APPENDIX A - TABLE OUTLINING ISSUES WITH REVISED CONCEPT DEVELOPMENT PROPOSAL No. SSD8707 – WITH RESPECT TO REVISED RESPONSE TO SUBMISSION (RTS) dated November 2019

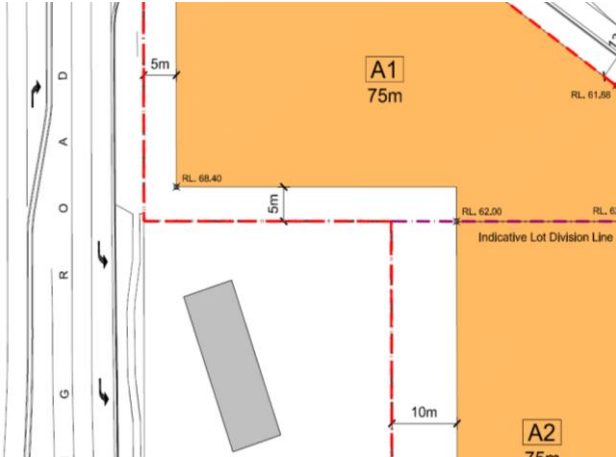
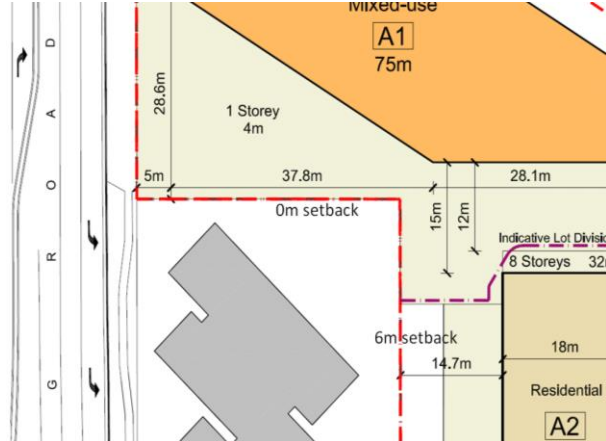
| # | ISSUES PREVIOUSLY RAISED By COUNCIL | REVISED RESPONSE TO SUBMISISON AS EXIBITED: NOV 2019 | CITY OF RYDE's POSITION ON THE ISSUES AFTER REVIEW OF THE NOVEMBER 2019 AMENDMENTS |
|---|---|---|---|
| 4 | <p>Building Setbacks</p> <p>Lack of regard for the adjoining approved building at 137-143 Herring Rd</p> <p>Nov 2019 Plan</p>  | <p>A setback of zero to 6m is proposed adjacent to the side and rear boundaries of No. 137-143 Herring Road.</p> <p>The revised response does not provide any further information or justification other than <i>"the one storey element of Building A2 and A3 has been set back 6 metres from 137-143 Herring Road"</i> and completely ignores the '0' setback for Building A1.</p> <p>A zero setback and any setback less than 10m is inadequate. The 6m setback to the rest of the building (A2 & A3) are not adequate to retain the contiguous vegetation along the boundary that links to the EEC. Especially the trees adjacent to Building A3 are important as it provides the visual link and buffer.</p> <p>In fact the revised plan is made worse off compared to the first scheme where the setback was 10m instead of 6m.</p> <p>The design, setbacks, envelopes on the subject site should establish a positive relationship with adjoining sites and environmental features. However, City of Ryde is still concerned that the basement, podium and ground floor level are still proposed to the boundary for most of the buildings (refer to Building A1, A2 & A3).</p>  <p>Original Concept Plan 2018 (10m setback)</p> | <p>The basement to the north west boundary has been set back '0' to 6 metres. The setbacks along north western side of the site are still unsatisfactory in that Building A1 basement and ground level is proposed on the boundary of 137-143 Herring Road site. Further the original setback of 10m along rest of the boundary has been reduced to 6m. This new setback needs to be assessed by the Arborist to determine what trees can be retained or to be removed.</p> <p>Council contends that trees need to be retained and additional deep soil areas need to be provided around the boundaries to allow for medium to large native trees to be planted. These deep soil areas need to be wider than 6m to enable retention of existing trees and allow future trees to grow. A 12m setback is required for adequate building separation to comply with the Apartment Design Guide. The Arborists Report does not provide any assessment of whether any trees would be retained along this side of the site.</p> <p>The 6m setback to the rest of the building (A2 & A3) are not adequate to retain the contiguous vegetation along the boundary that links to the EEC. Especially the trees adjacent to Building A3 are important as it provides the visual link and buffer.</p> <p>City of Ryde seeks the following:</p> <ol style="list-style-type: none"> The setback be increased to 12m throughout along the northwestern side boundary and adjacent to 13-143 Herring Road. This new setback needs to be assessed by the Arborist to determine what trees can be retained or to be removed.  <p>Revised November 2019 Plan (Compare setback – made worse)</p> |
